Design Review Board

Meeting Minutes

Mesa City Council Chambers - Lower Level, 20 East Main Street
Date: December 9, 2025 Time: 4:30 p.m.

Building Elevations – Building 1

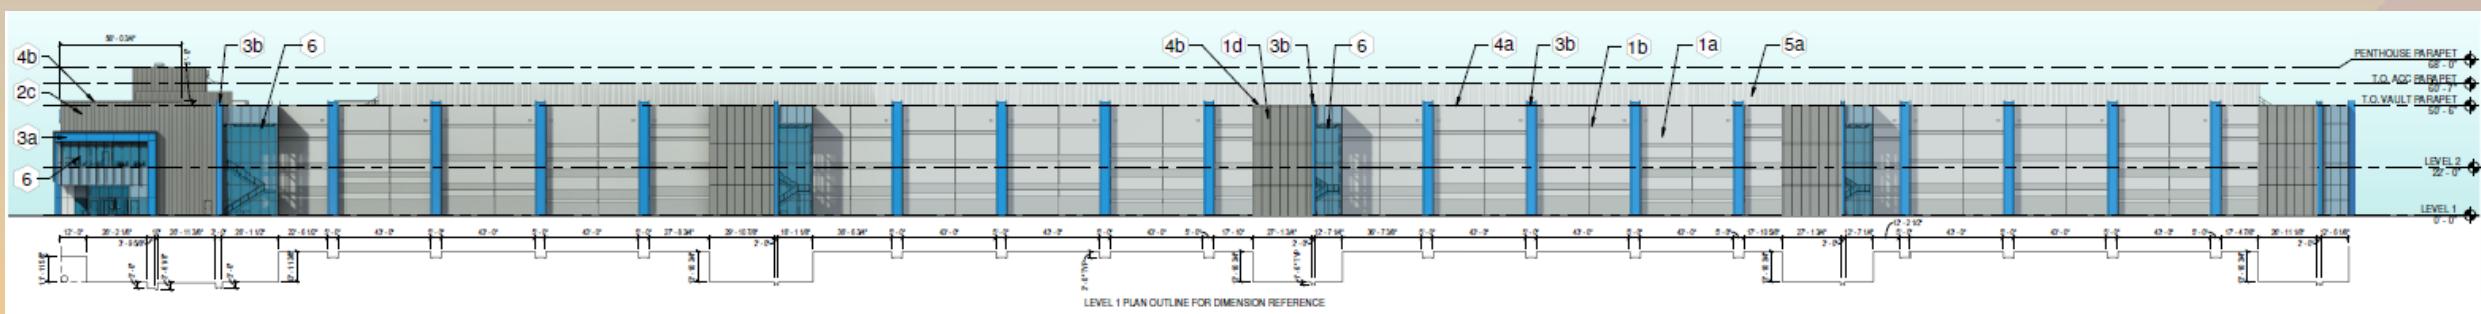
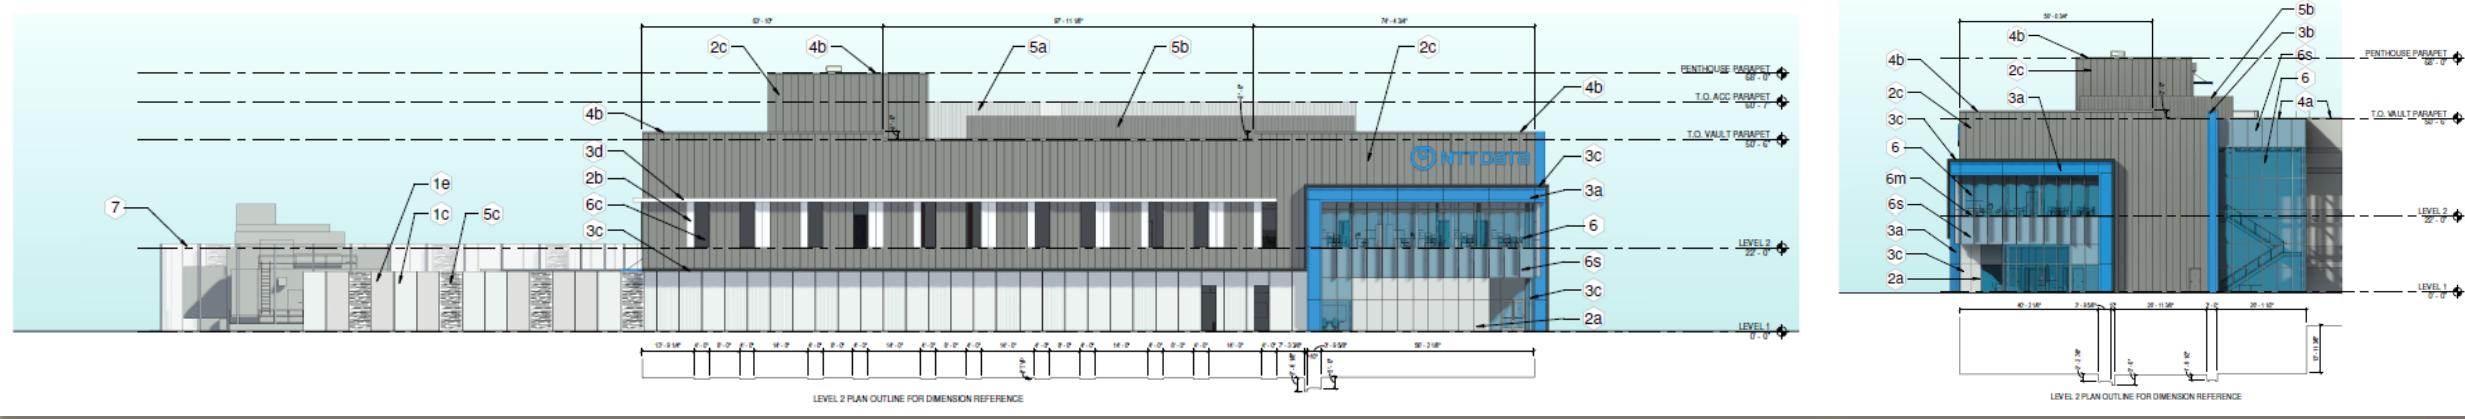
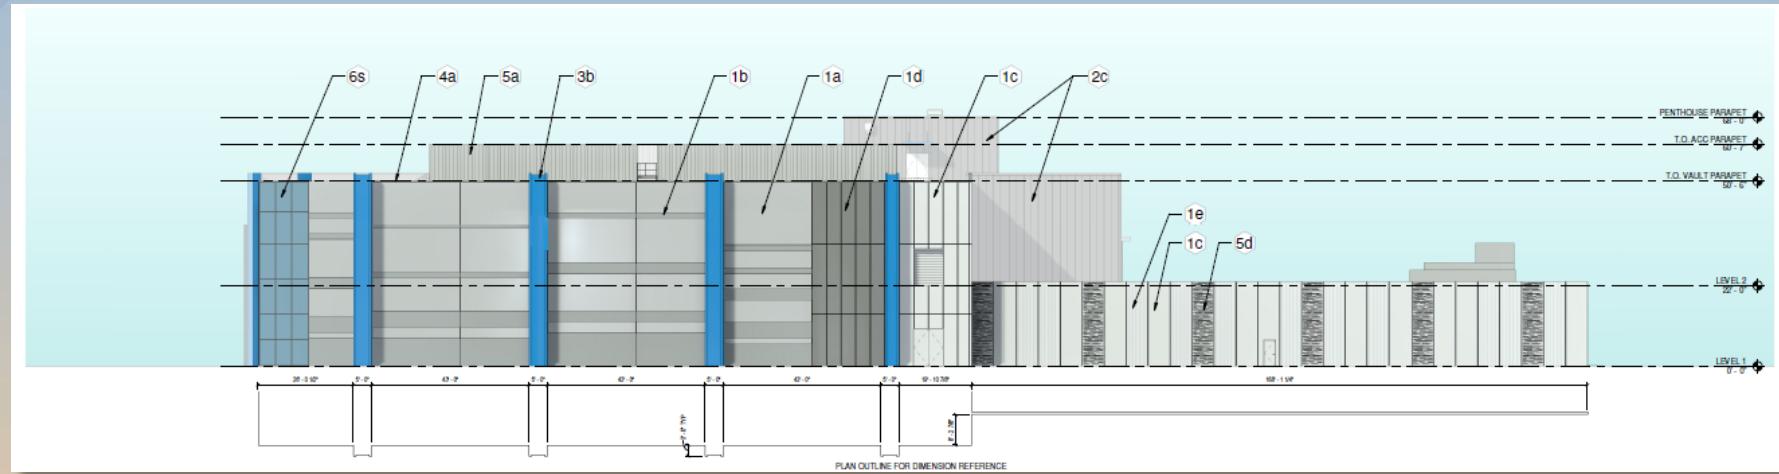
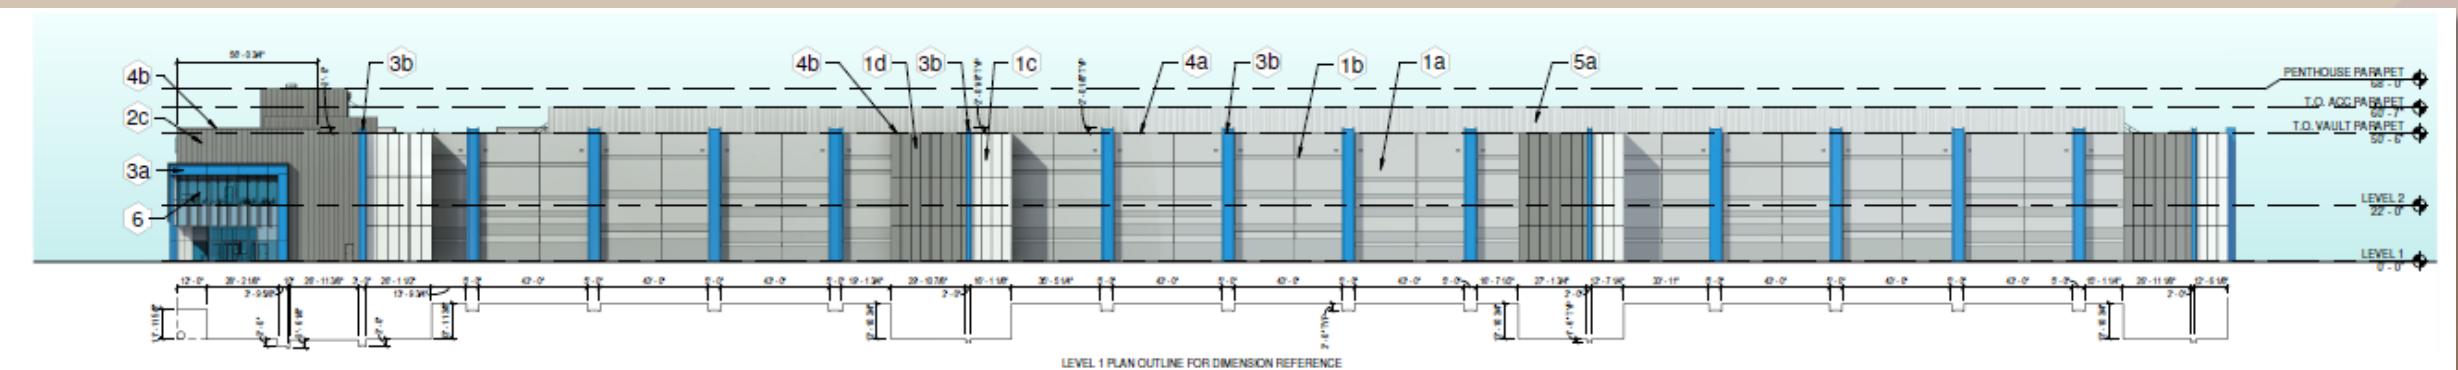
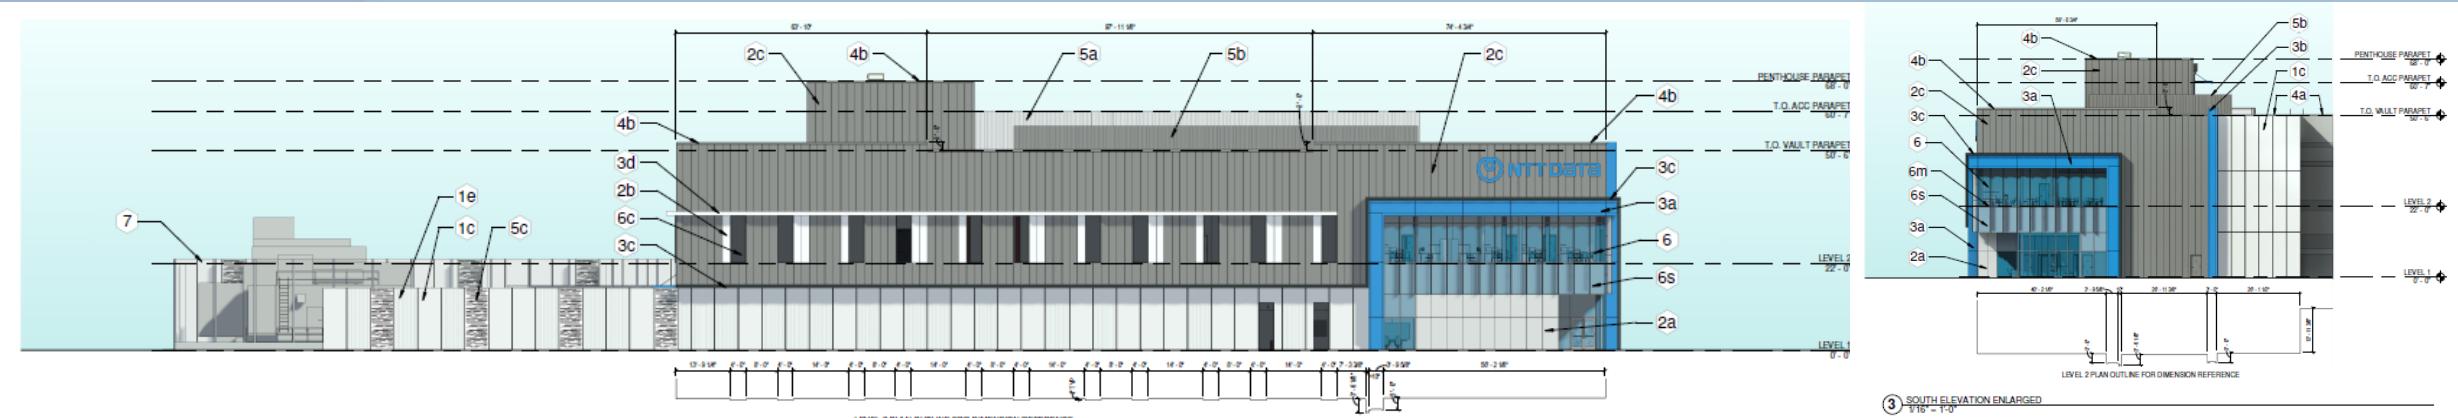
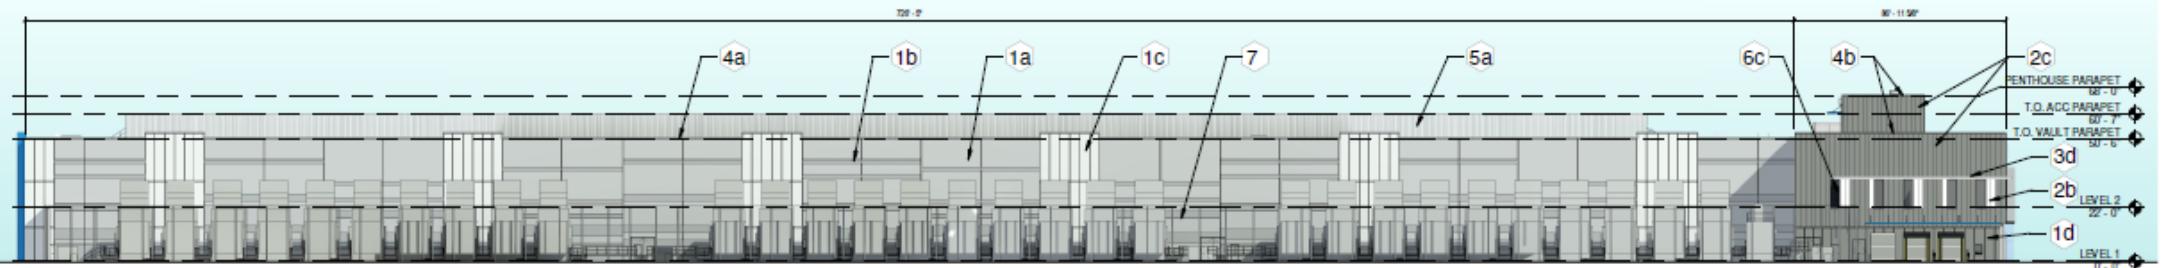
- Provide the architectural eyebrow only at the public entry area
- Confirm that there are no downspouts visible from outside the site
- Confirm that lighting is consistent with the AOA overlay allowances and that it creates elements along SR24
